CITY OF CODY
PLANNING, ZONING AND ADJUSTMENT BOARD AGENDA
TUESDAY, JULY 11, 2023 AT 12:00 P.M. (NOON)
CODY AUDITORIUM, 1240 BECK AVENUE, CODY, WY

CITY OF CODY PLANNING, ZONING AND ADJUSTMENT BOARD STAFF REPORT			
MEETING DATE:	JULY 11, 2023	TYPE OF ACTION NEEDED	
AGENDA ITEM:		P&Z BOARD APPROVAL:	X
SUBJECT:	CODY WYOMING TEMPLE OF THE CHURCH OF JESUS CHRIST OF LATTER-DAY SAINTS. SITE PLAN REVIEW. FILE NOS: SPR 2023-13	RECOMMENDATION TO COUNCIL:	
PREPARED BY:	TODD STOWELL, CITY PLANNER	DISCUSSION ONLY:

CITY OF CODY PLANNING, ZONING AND ADJUSTMENT BOARD STAFF REPORT			
MEETING DATE:	JUNE 27, 2023	TYPE OF ACTION NEEDED	
AGENDA ITEM:		P&Z BOARD APPROVAL:	X
SUBJECT:	SPECIAL EXEMPTION: HEIGHT OF STEEPLE FOR THE CODY WYOMING TEMPLE OF THE CHURCH OF JESUS CHRIST OF LATTER-DAY SAINTS. SUP 2023-08	RECOMMENDATION TO COUNCIL:	
PREPARED BY:	TODD STOWELL, CITY PLANNER	DISCUSSION ONLY:

CITY OF CODY PLANNING, ZONING AND ADJUSTMENT BOARD STAFF REPORT			
MEETING DATE:	JUNE 27, 2023	TYPE OF ACTION NEEDED	
AGENDA ITEM:		P&Z BOARD APPROVAL:	X
SUBJECT:	CODY WYOMING TEMPLE OF THE CHURCH OF JESUS CHRIST OF LATTER- DAY SAINTS. FILE NOS: SPR 2023-13, SUP 2023-08 (BOTH CUP AND SE) AND FNC 2023-01	RECOMMEND

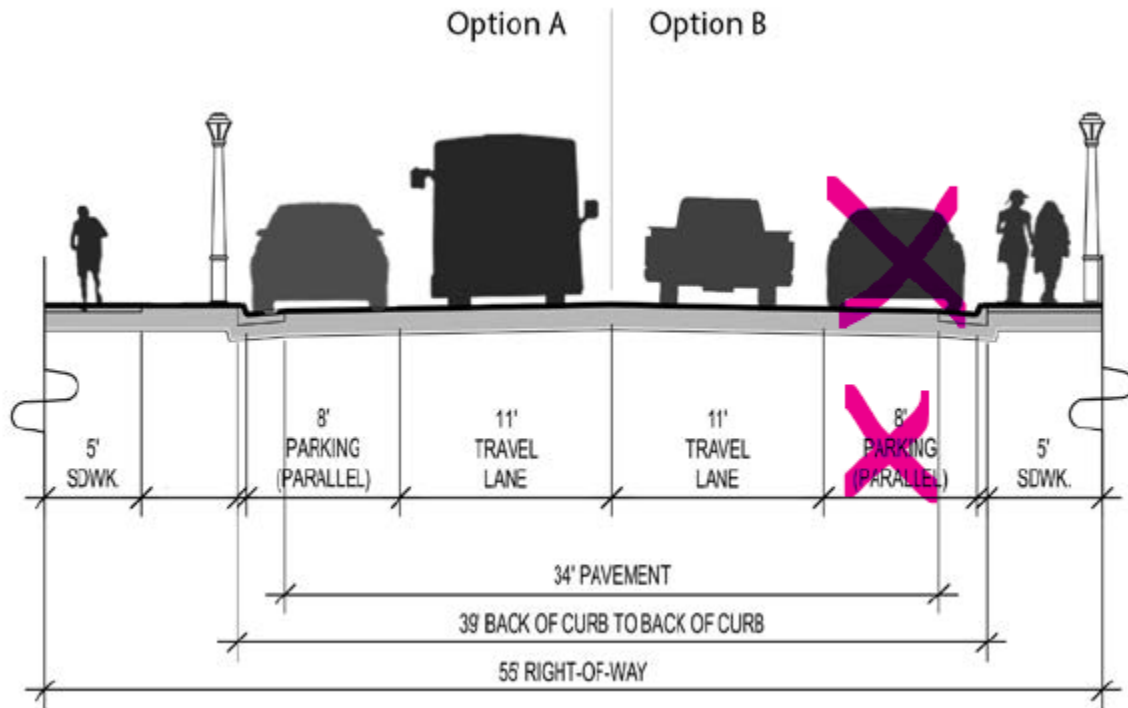
The proposed access situation is shown on the site plan. A new street, to be known as "Temple View Lane" will be constructed from Skyline Drive, along the south boundary of the temple site, ending in a cul-de-sac bulb. Two accesses to the temple site will be from that new street, as shown. Although the eastern temple access is on City right-of-way, City staff have indicated their preference that that section be privately maintained, to which the applicant has verbally agreed. With the designation of private instead of public, staff recommends a memorandum of understanding, simply outlining that it is a private improvement, with no maintenance responsibility for the City, and that if the right-of-way is ever developed with a public street, the party constructing that street would have the right to remove and/or reconfigure that access as needed, working in good faith with the property owner. Current City staff put the probability of that right-of-way being improved with a public street as extremely close to zero—way too costly and way too constrained by existing utilities and topography to justify such minimal traffic circulation benefit.

As the temple site has abundant on-site parking, there is no justification for requiring on-street parking along the north side of Temple View Lane. However, width for on-

street parking will be provided on the south side of Temple View Lane. Due to safety reasons (e.g. sight distance around the curve of Temple View Lane), there will be no parking in the intersection area of Temple View Lane and Skyline Drive—the street width is not designed in that area to provide parking on either side.

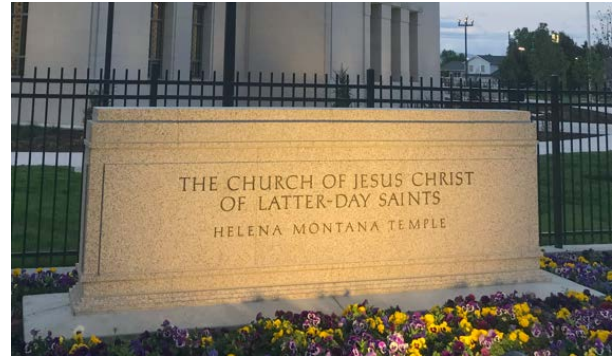
While City staff (P.W. and Planning) are generally okay with the utilities as proposed, we are open to modifications that may result from the following requirements and suggestions.

- a) The fire marshal states that one additional fire hydrant should be added to the temple site and one at the end of the cul-de sac. The additional hydrant for the temple site is recommended to be in the island near the fire line valving directly east of the temple building.
- b) If desired, the stormwater piping may be able to be reduced by relying more on gutter flow in the street entrance areas. In addition, the pipe to the ravine seems larger than needed.
- c) Black Hills Energy requests additional separation between the proposed natural gas line and the perimeter fence and electrical line. That could involve adjusting things a few feet, or just moving the gas line to the south side of Temple View Lane.

The electrical plan generally appears fine, but is missing the line from the existing fuse cabinet to the proposed transformer next to Skyline Drive. Also, shift the proposed transformer slightly to allow room for a future sidewalk along Skyline Drive (min. 5 feet behind back of curb.)

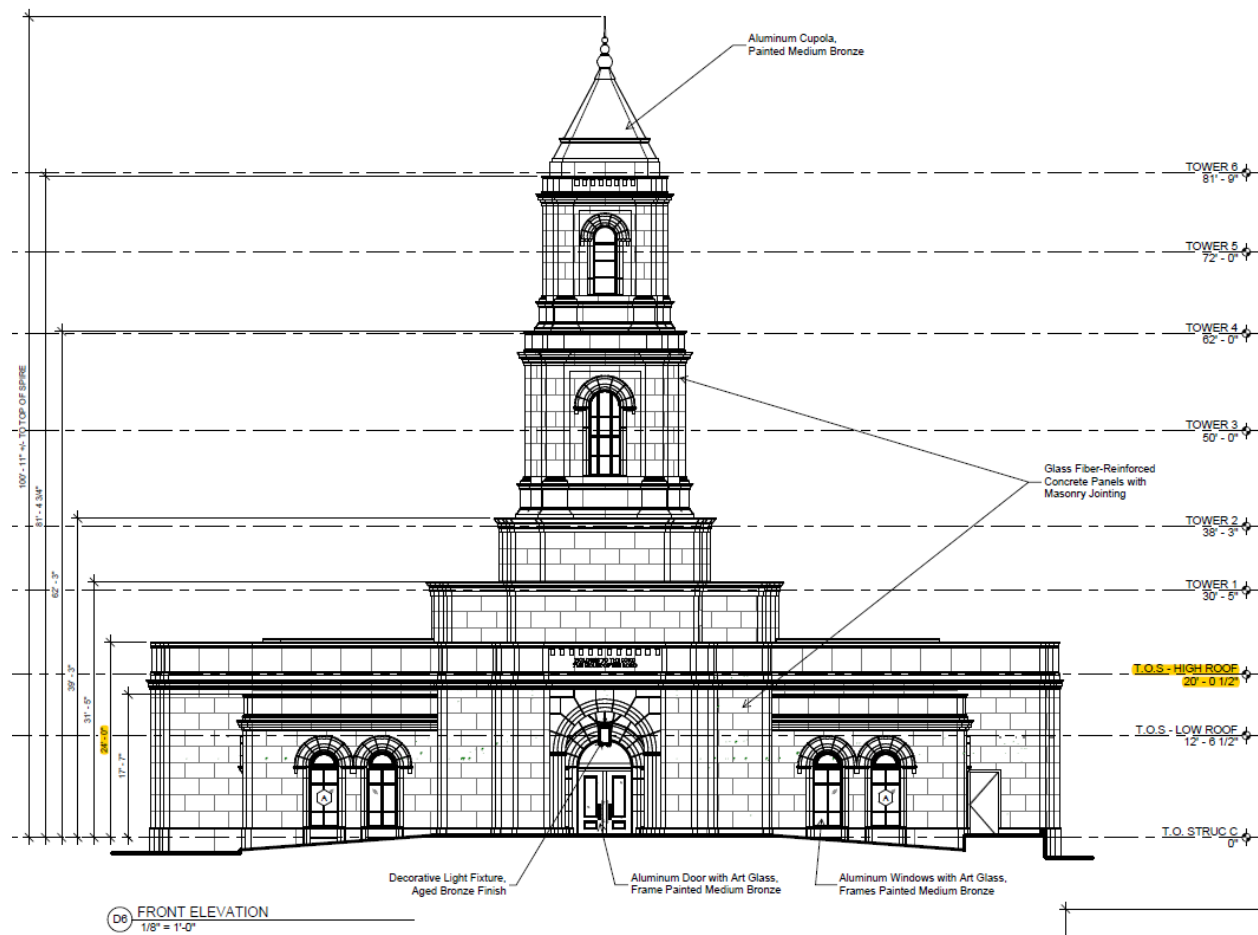
Now we must analyze whether the temple complies with the “maximum building height” standard, which is 30 feet.

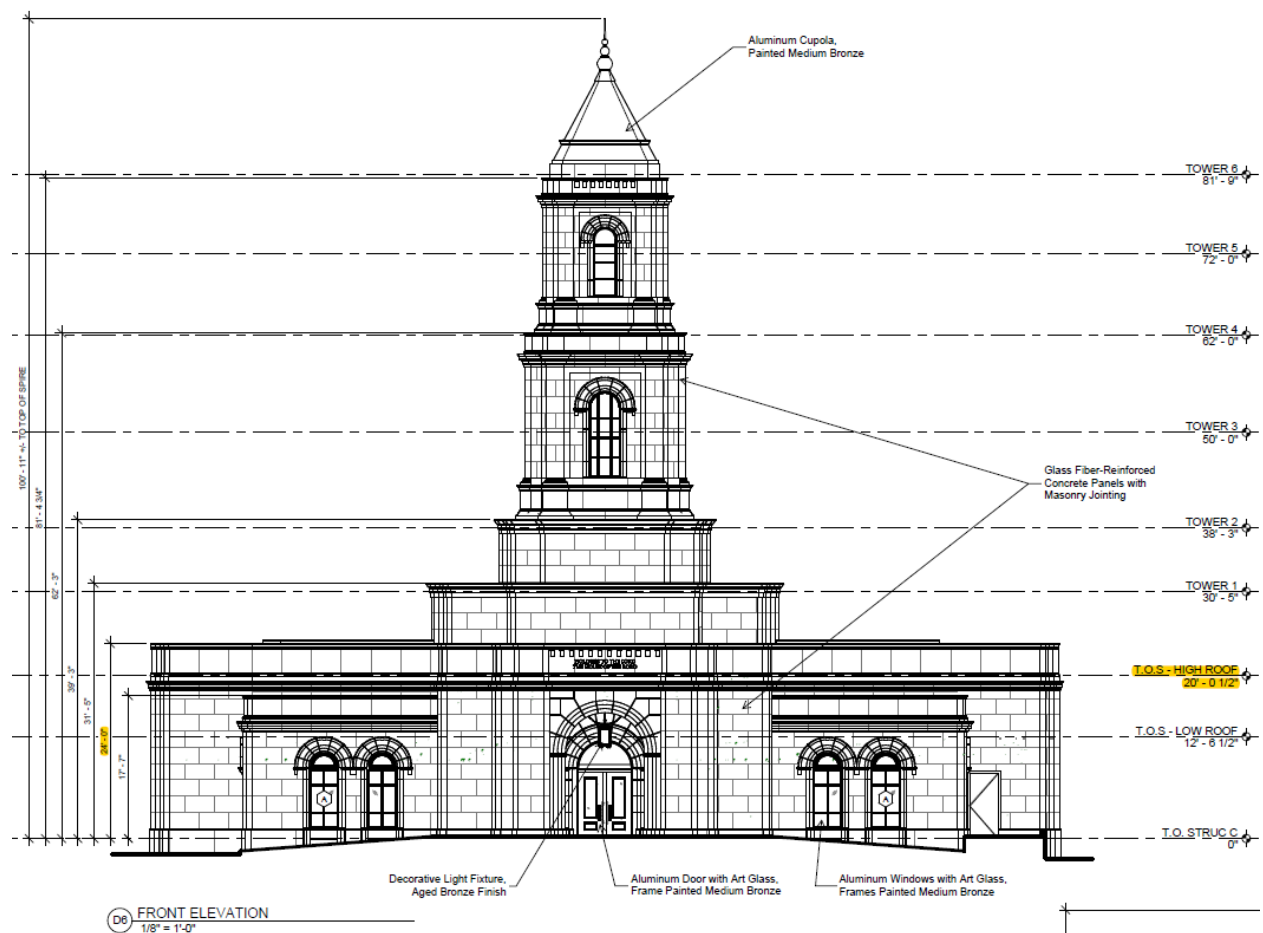
Now we must analyze whether the temple complies with the “maximum building height” standard, which is 30 feet.

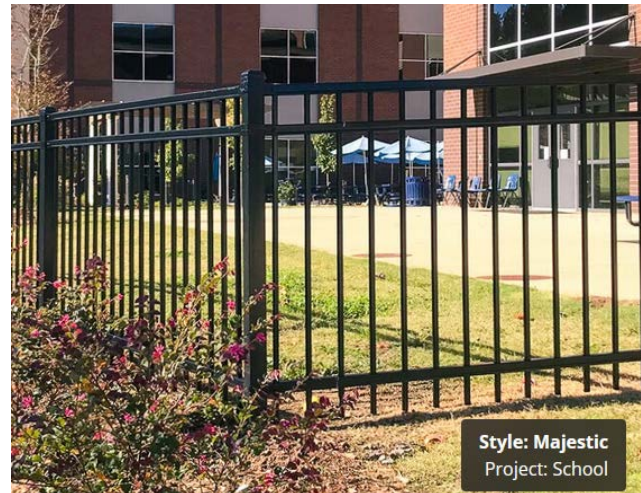
No trees are authorized in the City right-of-way along the east side of the temple site. Any shrubs, bushes and other woody vegetation placed in the City right-of-way will need to meet the standards of City code [7-4](#) (relates to spacing from utility lines). The landscaping plan will need to be revised accordingly. Grass or other groundcover in that area remains an option. Any disturbed areas beyond the landscaped areas that lack vegetation are to be planted with dryland grass seed, or any better alternative method authorized by Public Works, to help prevent weeds and control erosion.

Landscaping in the immediate area around the electrical switch gear cabinet must consider the minimum clearances required. Depending on the size of the cabinet, some of those shrubs shown nearest the cabinet may need to be removed from the plan.

9. Prior to installation of the landscaping, provide an updated landscaping plan that shows the removal/shifting of the trees to be off the City right-of-way, and demonstrates the necessary clearance around the switch gear cabinet.

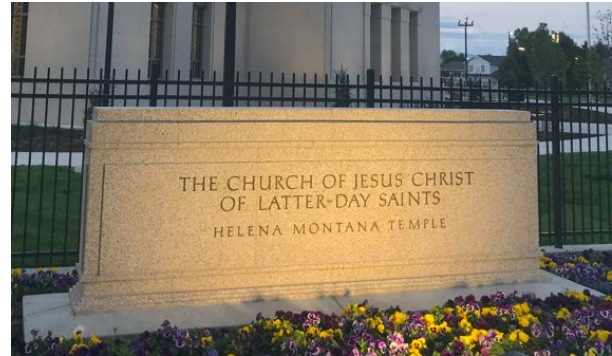
While City staff (P.W. and Planning) are generally okay with the utilities as proposed, we are open to modifications that may result from the following requirements and suggestions.

- a) The fire marshal states that one additional fire hydrant should be added to the temple site and one at the end of the cul-de sac. The additional hydrant for the temple site is recommended to be in the island near the fire line valving directly east of the temple building.
- b) If desired, the stormwater piping may be able to be reduced by relying more on gutter flow in the street entrance areas. In addition, the pipe to the ravine seems larger than needed.
- c) Black Hills Energy requests additional separation between the proposed natural gas line and the perimeter fence and electrical line. That could involve adjusting things a few feet, or just moving the gas line to the south side of Temple View Lane.

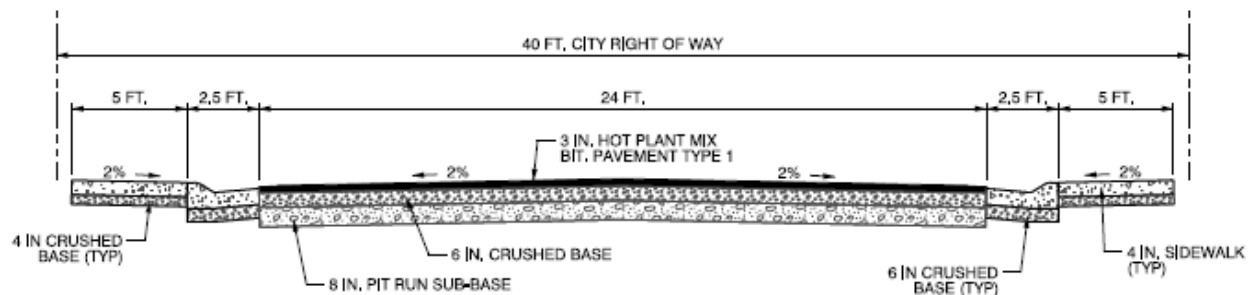
Comment: The typical street cross section, as identified in the street master plan is shown here, and includes a 34-foot-wide asphalt surface, with curb and gutter, and 5-foot-wide sidewalks on each side.

The application requests a reduction in the asphalt surface to 24 feet, as depicted here.
